Well Name: POKER LAKE UNIT 20 DTD	Well Location: T24S / R30E / SEC 20 / NENW / 32.207749 / -103.904756	County or Parish/State: EDDY / NM
Well Number: 221H	Type of Well: CONVENTIONAL GAS WELL	Allottee or Tribe Name:
Lease Number: NMNM02860	Unit or CA Name: POKER LAKE UNIT	Unit or CA Number: NMNM71016X
US Well Number:	Operator: XTO PERMIAN OPERATING LLC

Notice of Intent

Sundry ID: 2779002

*Changes approved through engineering via **Sundry 2779002** on 04/04/2024. Any previous COAs not addressed within the updated COAs still apply.*

DRAWING NO. HBE0000833

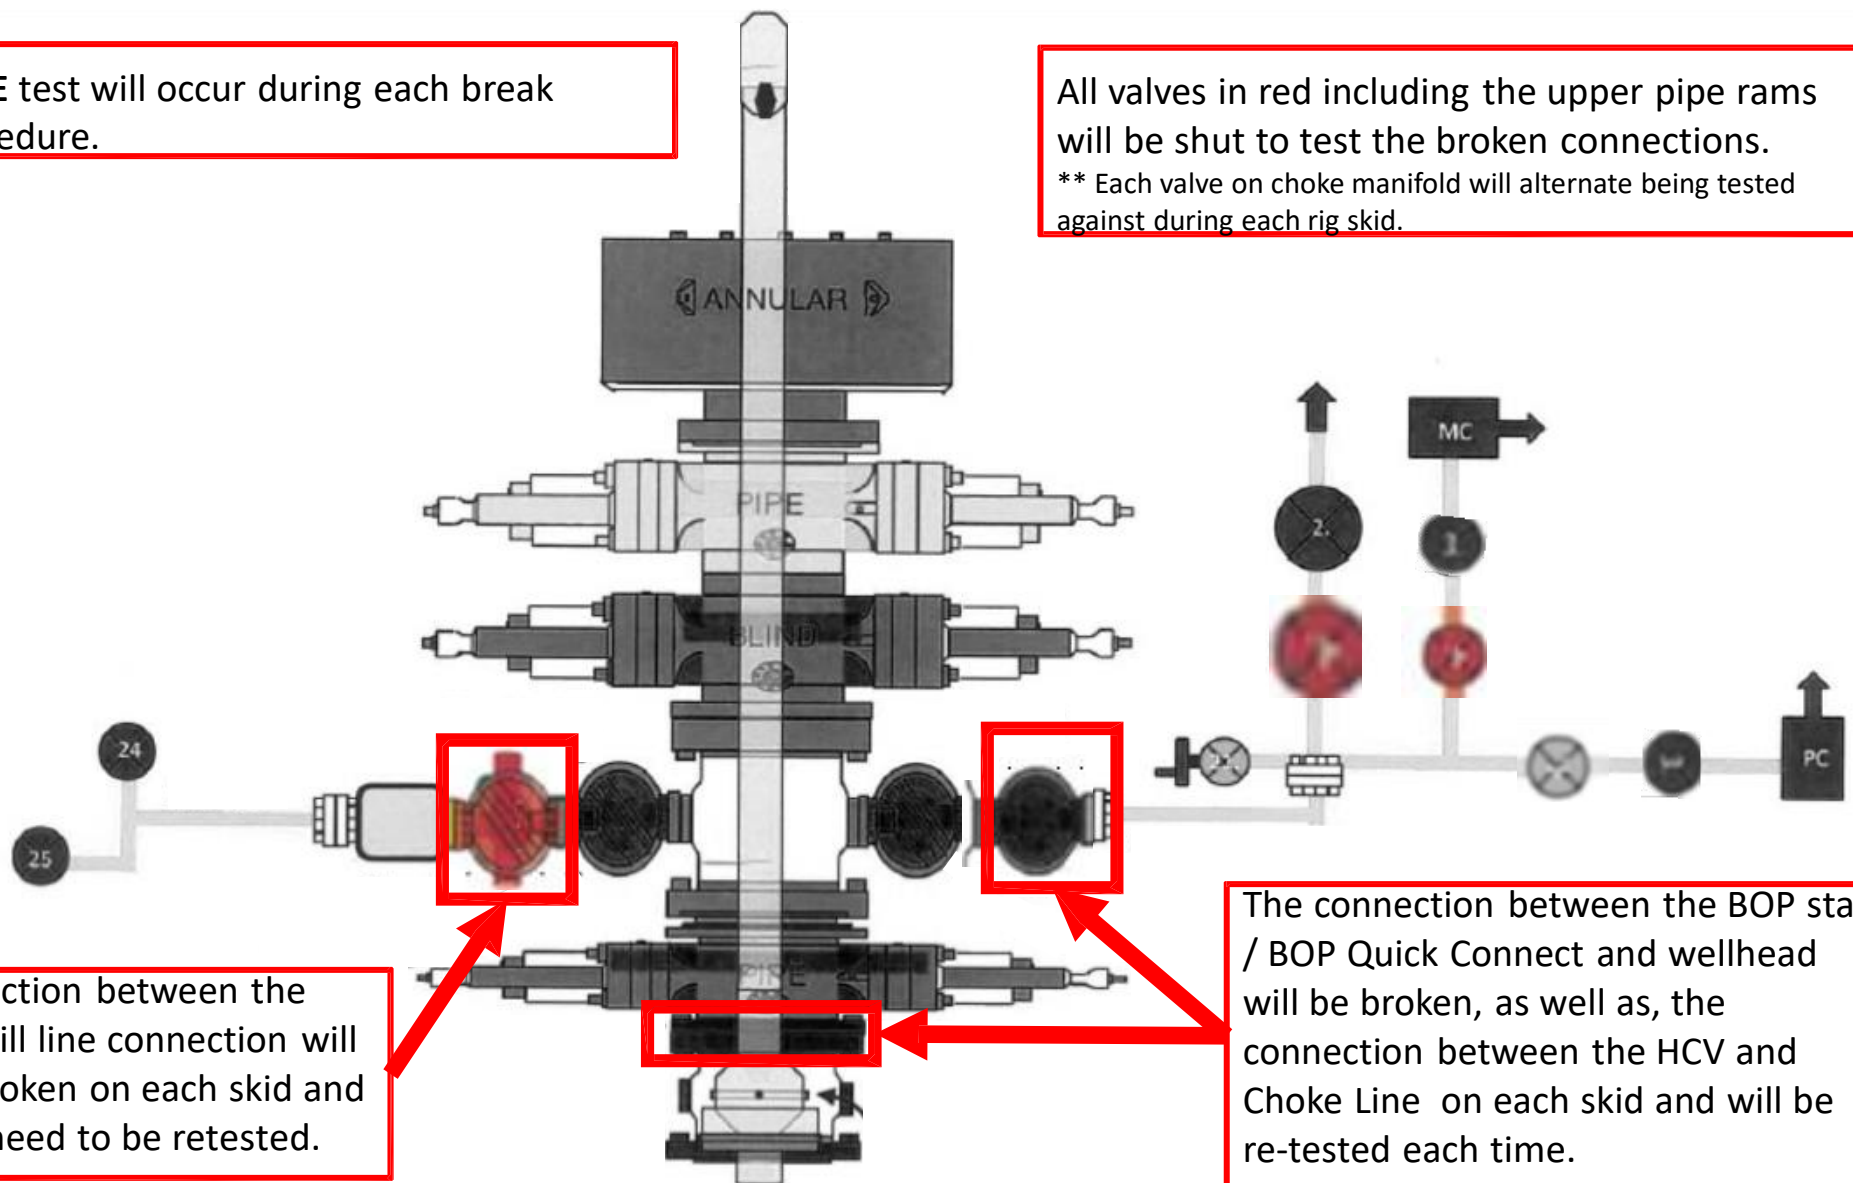
Note: Picture below highlights BOP components that will be tested during batch operations

Only **ONE** test will occur during each break test procedure.

All valves in red including the upper pipe rams will be shut to test the broken connections.
** Each valve on choke manifold will alternate being tested against during each rig skid.

The connection between the HCV and kill line connection will **NOT** be broken on each skid and does not need to be retested.

The connection between the BOP stack / BOP Quick Connect and wellhead will be broken, as well as, the connection between the HCV and Choke Line on each skid and will be re-tested each time.
